TOWN OF GLASTONBURY
GL-2021-05
GLASTONBURY HIGH SCHOOL ATHLETICS FACILITY
ADDENDUM NO. 2
December 10, 2020

A. RFI Questions and Answers:

C. Drawing Clarifications/ Revisions:

PAVERS ON CONCRETE BASE-PEDESTRIAN
SCALE: NONE

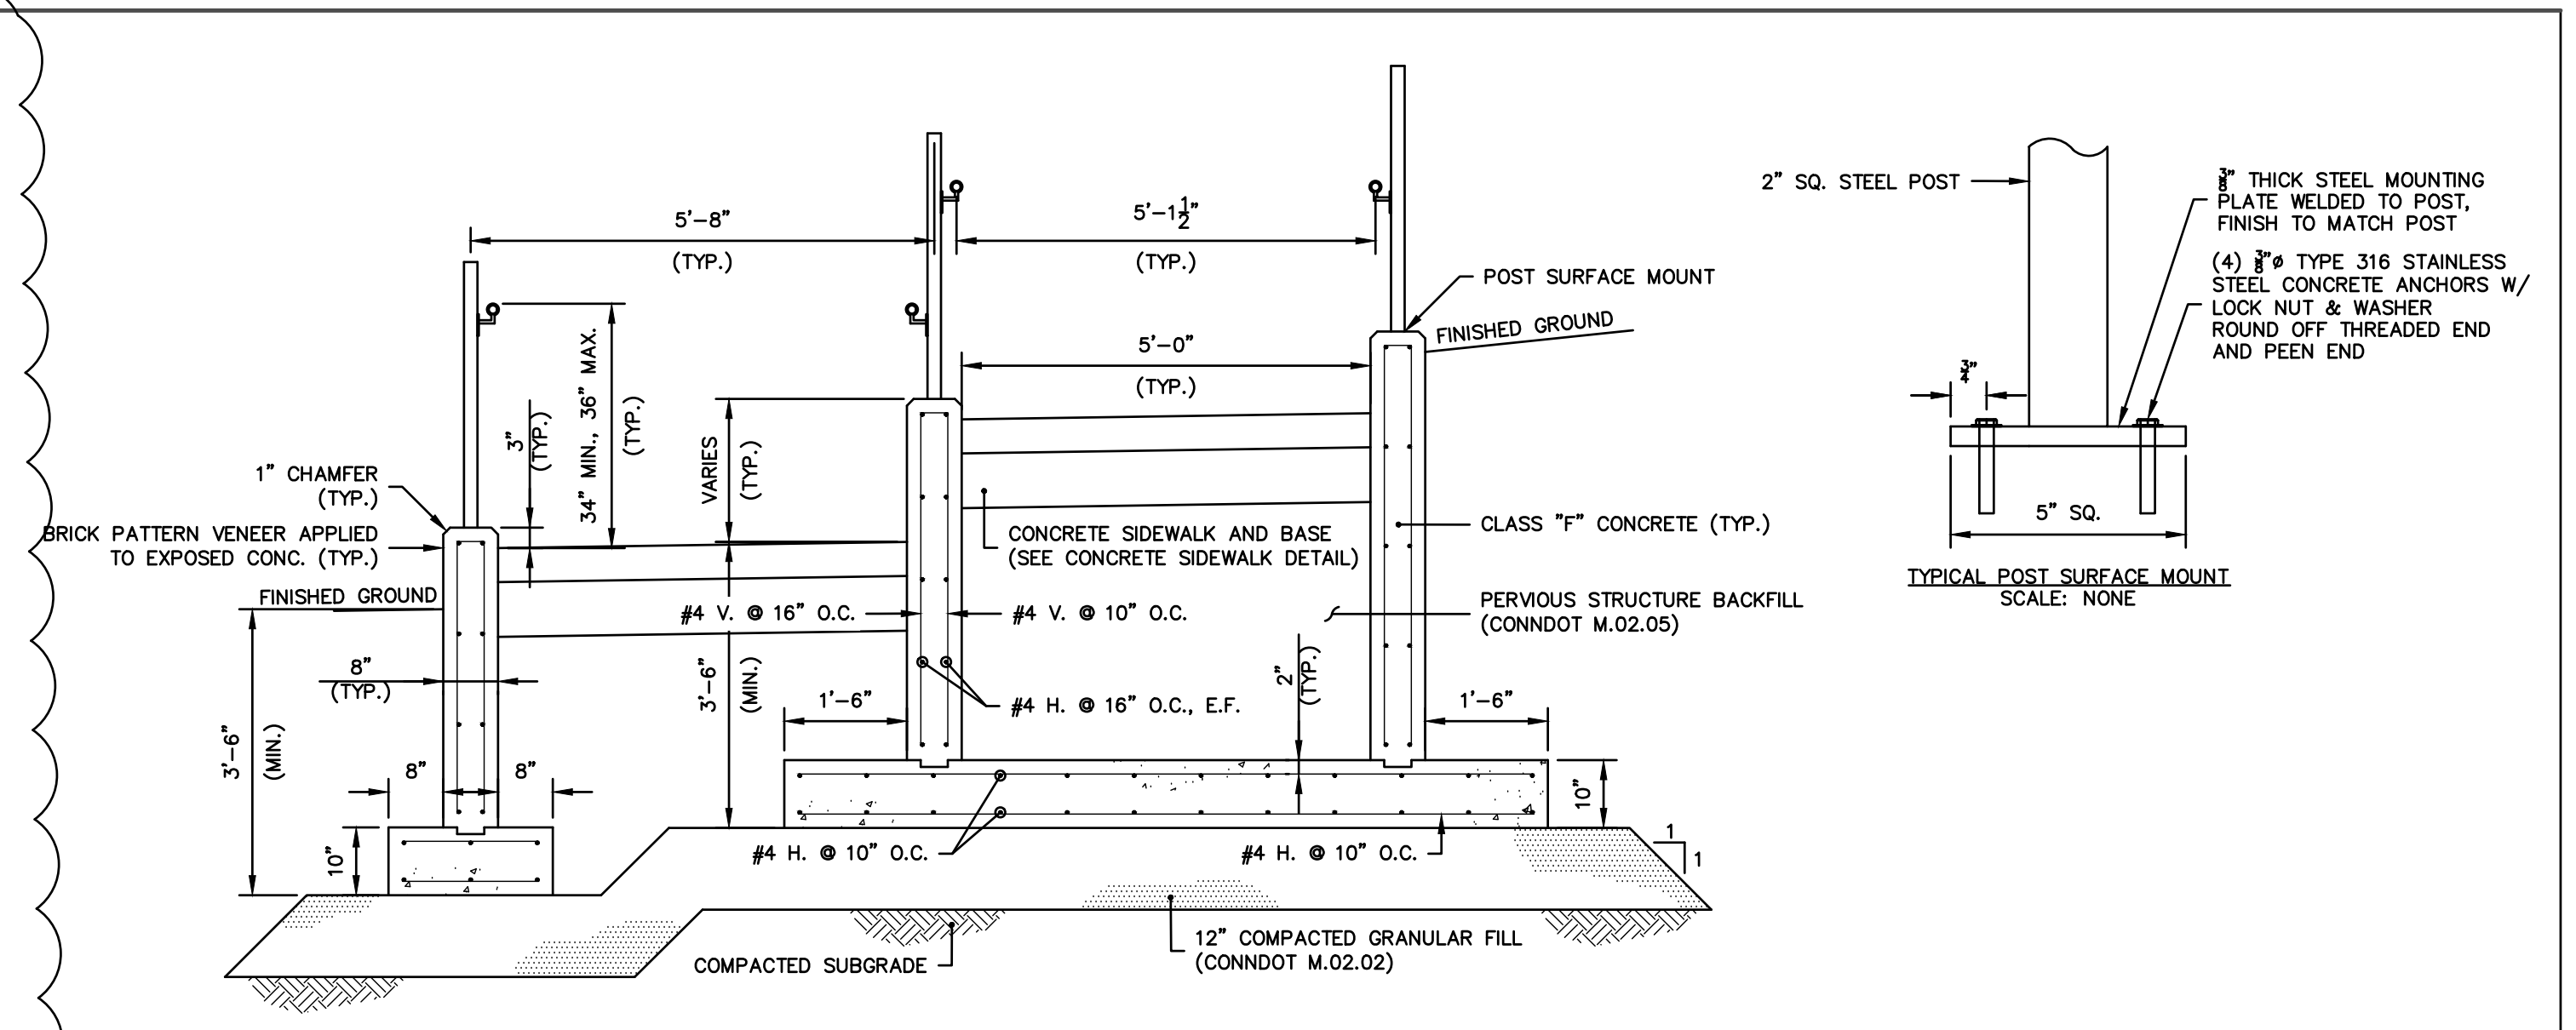
Question 34: *Provide details for subgrade materials under brick pavers.*

Question 40: *There are no details or information for the restoration of the memorial brick pavers. Is the town responsible for the subgrade and restoration of the pavers?*

Answer: See detail on Sheet C-6.1.

Answer: Refer to detail on C-6.1 for installation of pavers. Subgrade work as described in Alternate #3 shall be included in the pricing of Alternate #3. Restoration of the pavers shall be included in the base bid.

CAST-IN-PLACE CONCRETE SWITCHBACK RAMP
SCALE: NONE

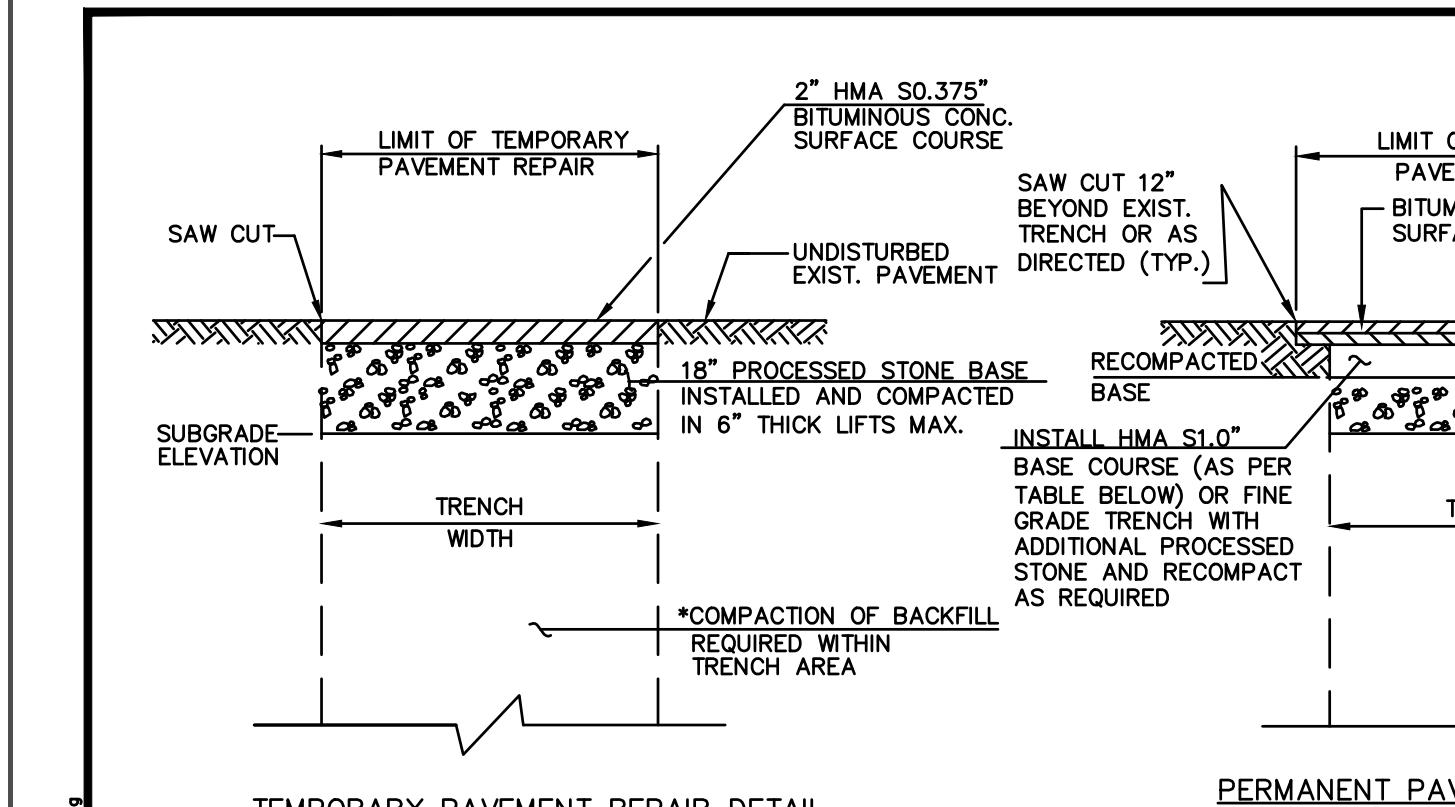
Question 5: *Can dimensions be provided for the new switchback ramp on the Civil drawings?*

Answer: Dimensions have been added to Sheet C3.0

TEMPORARY AND PERMANENT PAVEMENT REPAIRS
SCALE: NONE
DRAWN BY: SR
CHECKED BY: SMI
APPROVED BY: DAP
LAST REVISED: 3/28/2017

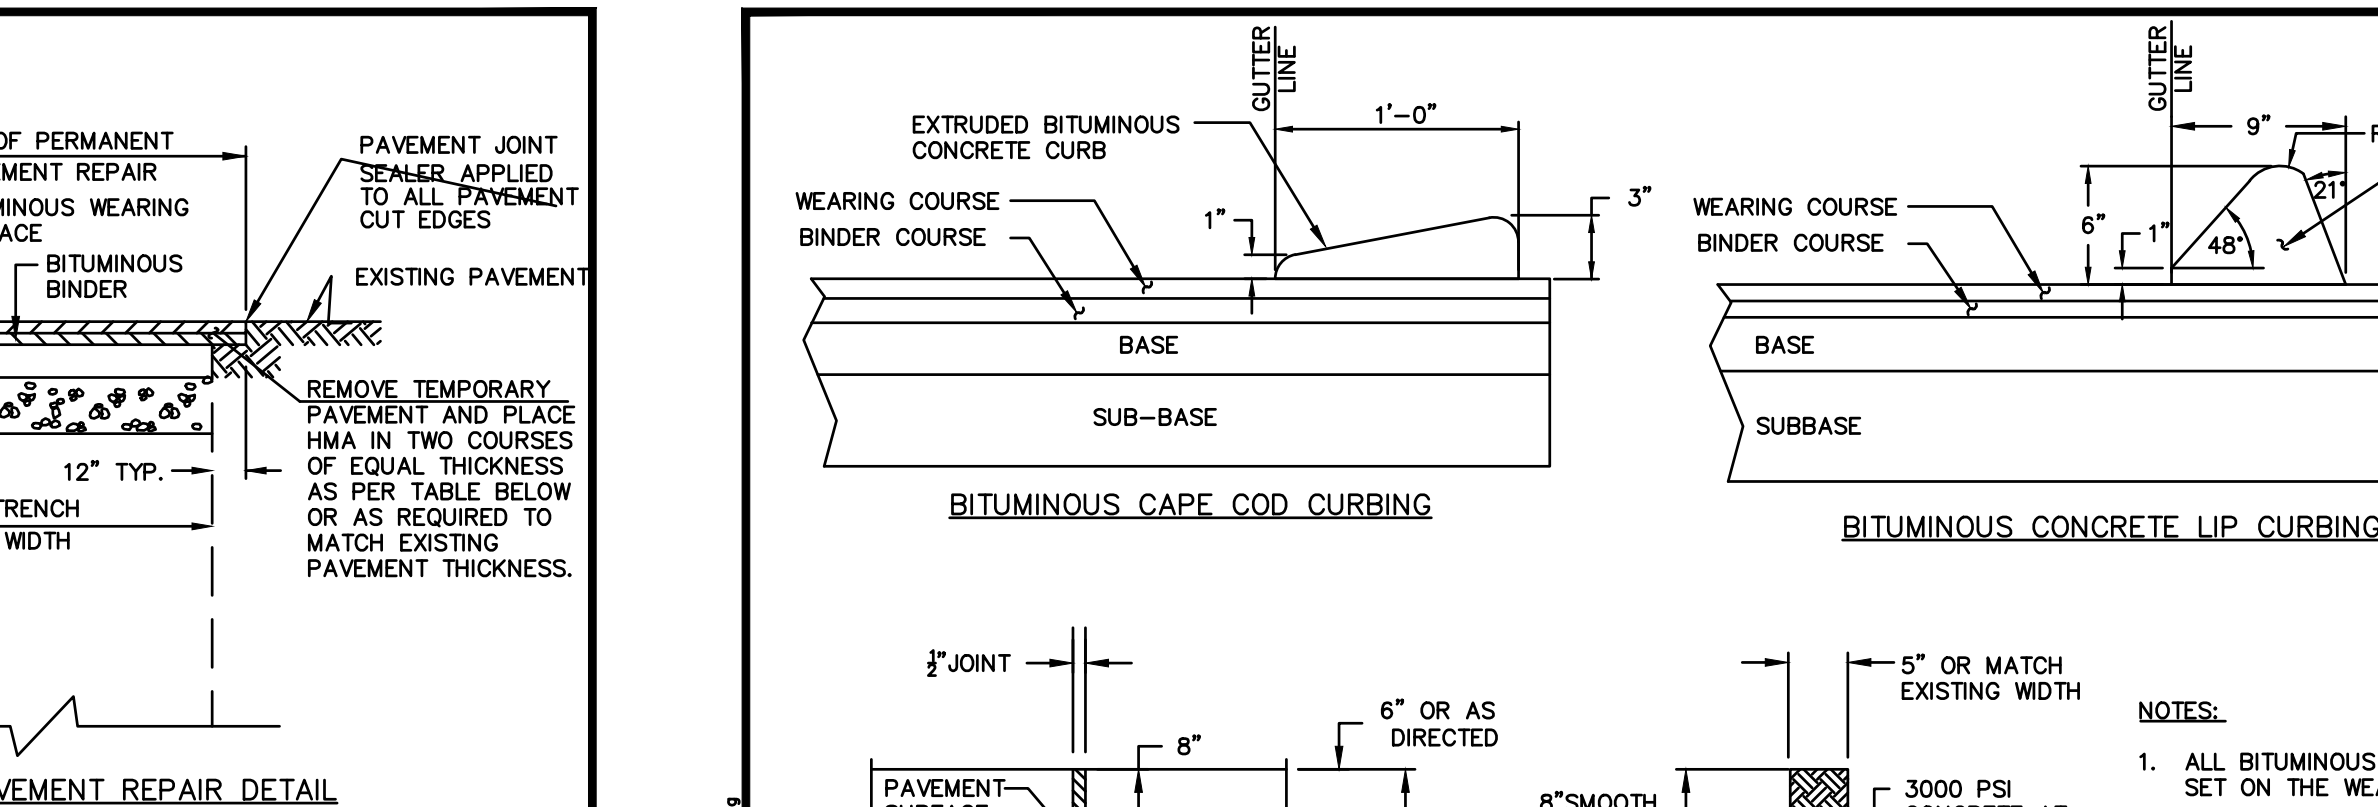
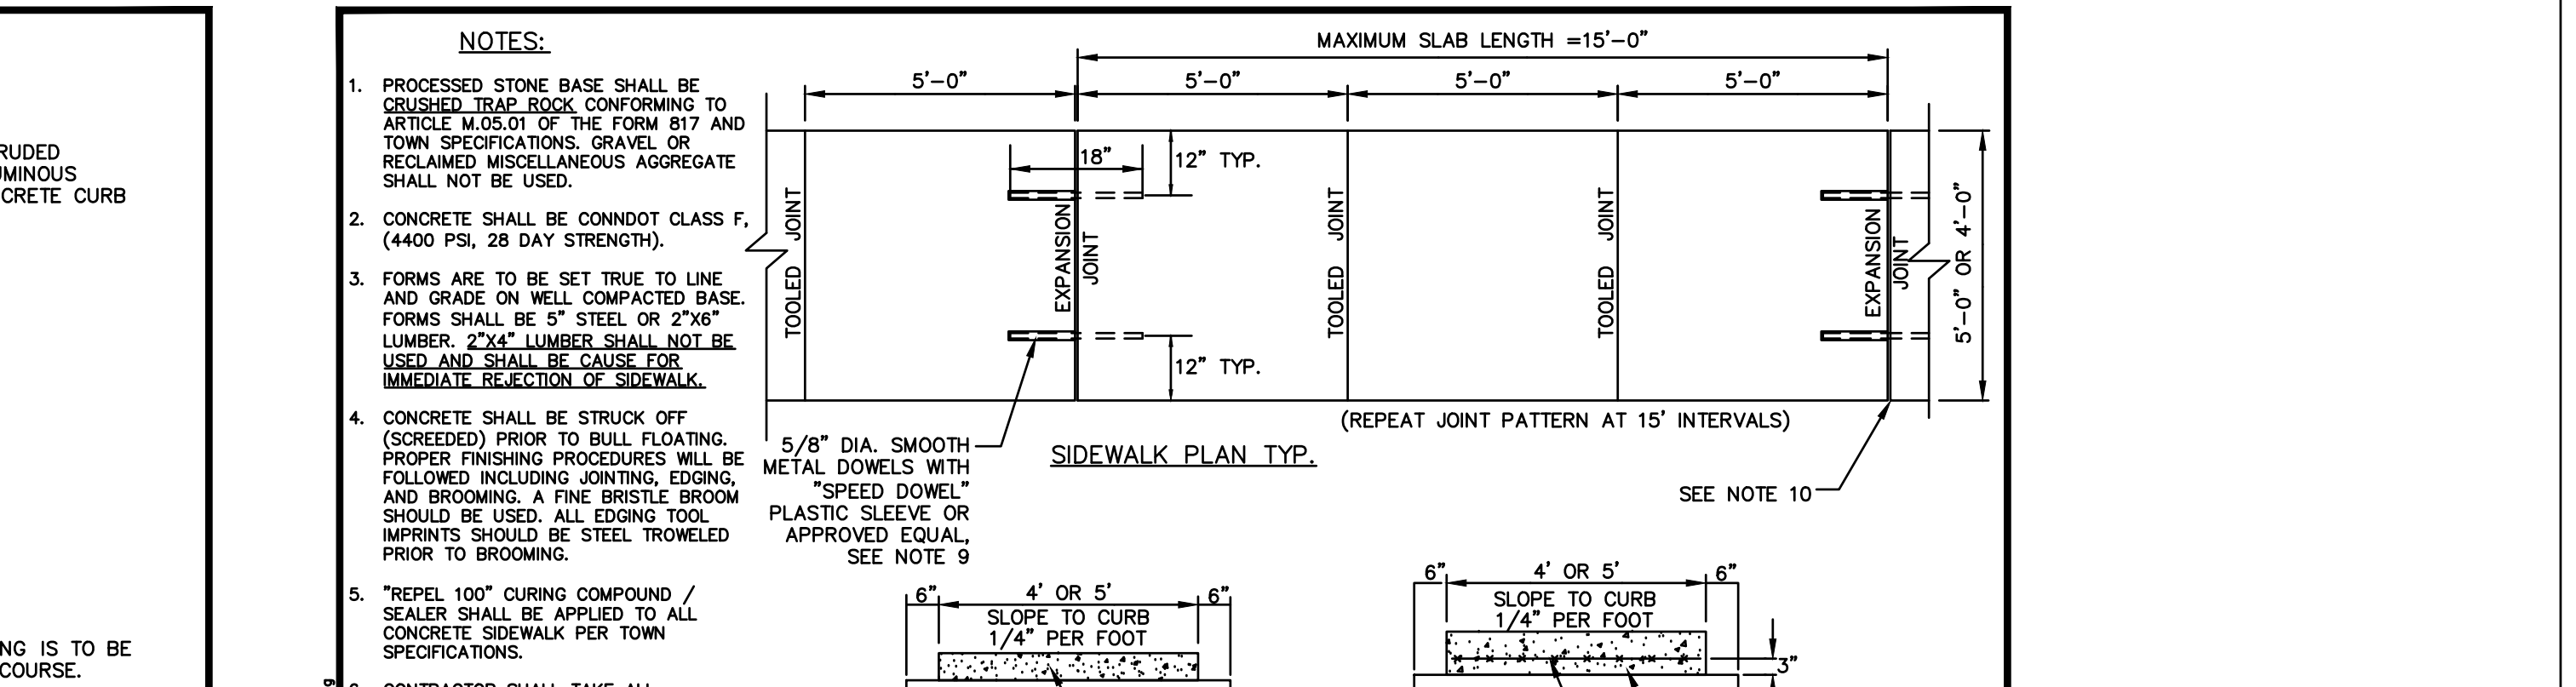
Question 37: *For the asphalt paving, please provide a detail showing the thickness of pavement. The detail provided as “pavement repair” does not provide adequate information to bid properly.*

Question 38: *The only detail for the paving is a temporary and permanent “road” patch detail. This seems a little excessive for the parking areas, Is this really the detail we are to follow for the parking lot? If so, which detail are we to use – the temporary or the permanent patch - as there are different amounts of subgrade material for each?*

Answer: Refer to the detail on C-6.0.

Answer: Refer to the detail on C6.0.
